Product Changes in comparison – Pitch 3,5

Product Changes in comparison – Pitch 3,81

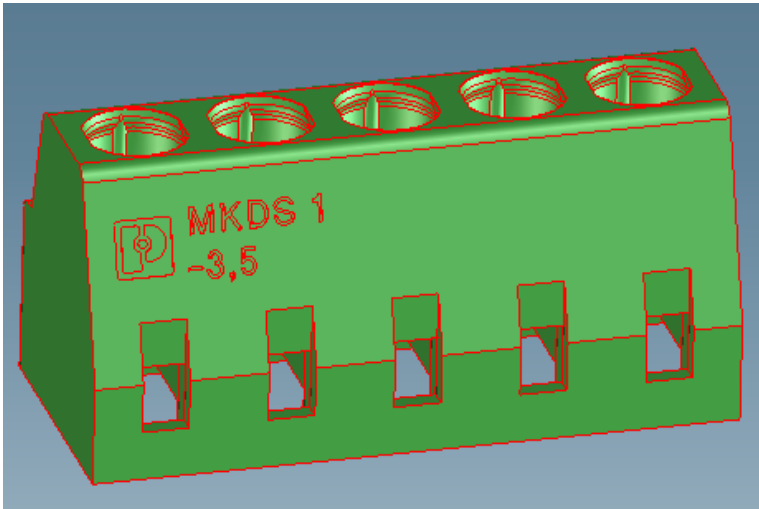
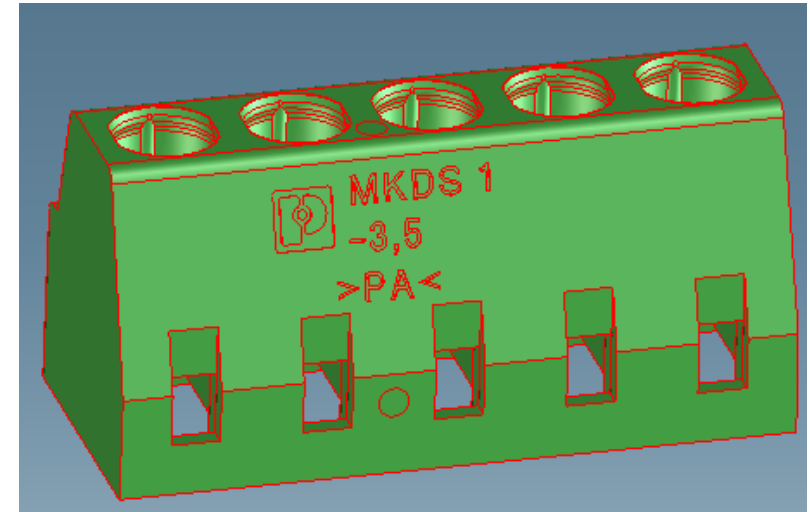
- Labeling in future centered instead of one-sided
- Side walls 0.5° conical
- New imprint on top of the housing

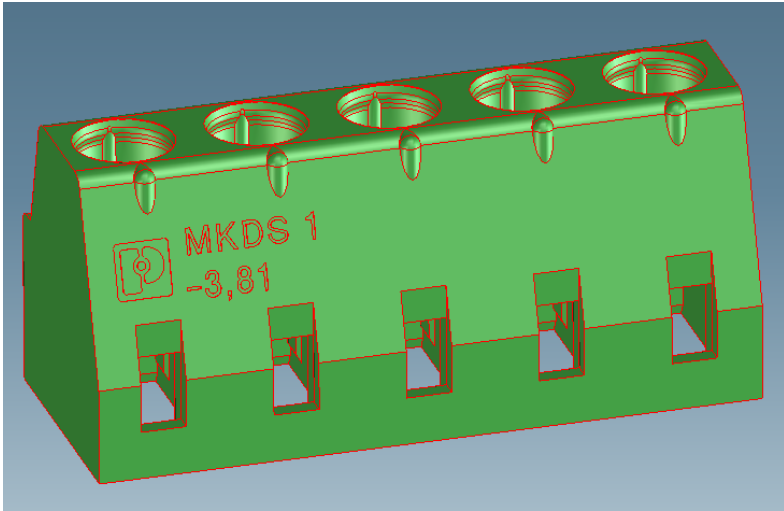
- Labeling in future centered instead of one-sided
- Side walls 0.5° conical
- New imprint on top of the housing

- Screw shaft with surface
- Recognition wart -3.81 offset

- Insertion chamfers in the area of the terminal sleeves
